State of Utah DEPARTMENT OF NATURAL RESOURCES Division of Oil, Gas & Mining

Inspection Report Minerals Regulatory Program March 5, 2013

Mine Name: Bull Claim Hill Operator Name: Sevier County

Permit number: S/041/0037 **Inspection Date:** February 25,

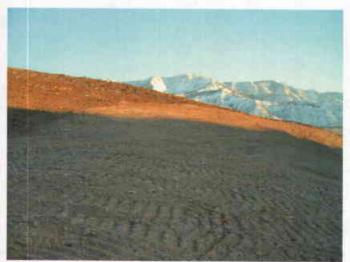
The majority of the site has been regraded and blends nicely with surrounding areas (Photos 1 and 2). There is one area on the northwest side that still has a stockpile of gravel (Photo 3), and there is one place toward the southeast where the slope is very steep leading into a catch basin (Photo 4).

The entire area needs to be monitored for revegetation and erosion. In particular the steep slope on the southeast should be checked periodically for erosion.
